# MEMORANDUM

To: Salt Lake City Historic Landmark Commission  
From: Kelsey Lindquist (385) 226-7227  
Date: April 28, 2022  
Re: Union Pacific Railroad Station Hotel Building & Major Addition PLNHLC2018-00616

This memorandum provides updated information on the proposed Union Pacific Railroad Station Hotel Building and Major Alteration. This proposal was approved by the Historic Landmark Commission on May 2<sup>nd</sup>, 2019. Since the approval, the applicant has worked with staff to satisfy the imposed conditions by the Historic Landmark Commission. The applicant subsequently submitted building permits to Building Services for a core and shell permit. Staff reviewed the building permit submittal and noted several discrepancies between the approved plans and the building permit plans. The applicant identified the changes to the approval and staff determined that the **requested changes are beyond staff's discretion**, and therefore the revisions are being forwarded to the commission for a decision.

# EXISTING SIGNAGE RELOCATION

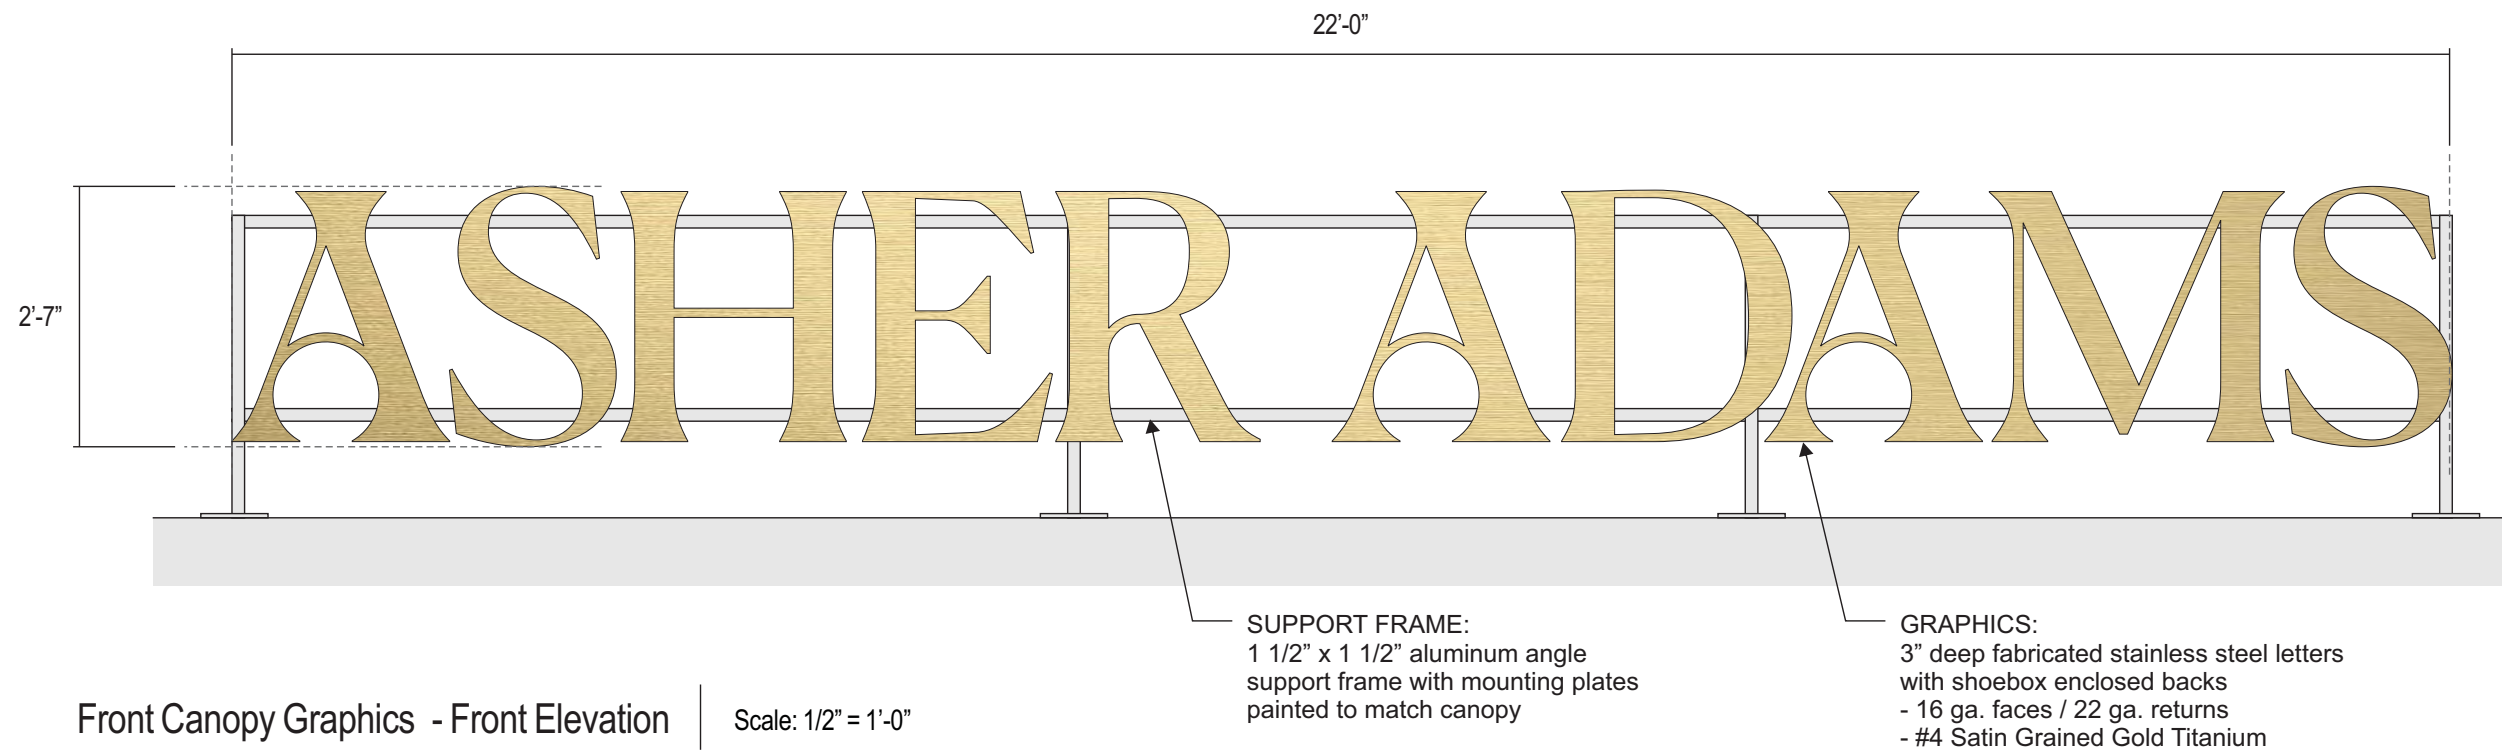
Relocated Gateway sign

Relocated Directory

Relocated Depot marquee
